CITY OF ALBUQUERQUE

APS Rankin Training Facility Grading and Drainage Plan Engineer's Stamp Date 2-16-2016 (File:G15D061)

GRADING AND DRAINAGE PLAN

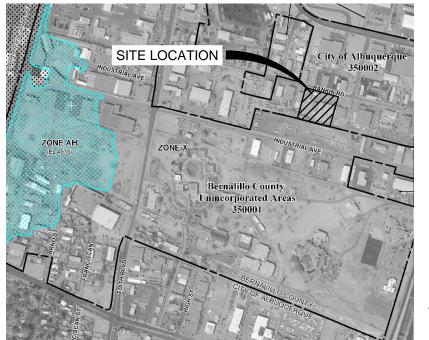
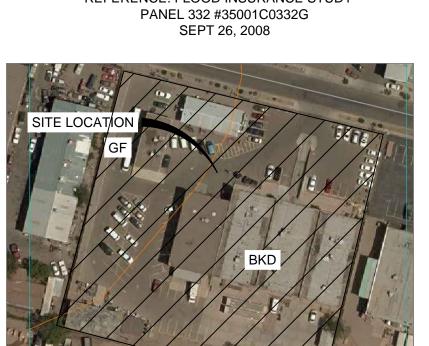
- 1. The crusher fine parking areas should be graded away from the pavement edges, or the pavement section will be subject to subgrade failure and eventual edge cracking. This will be a requirement, if during the C.O. inspection it becomes apparent that sediment will wash onto the street during a storm.
- 2. A cut-off wall (or narrow edge curbing) should be considered to maintain the integrity of the new edges of asphalt.
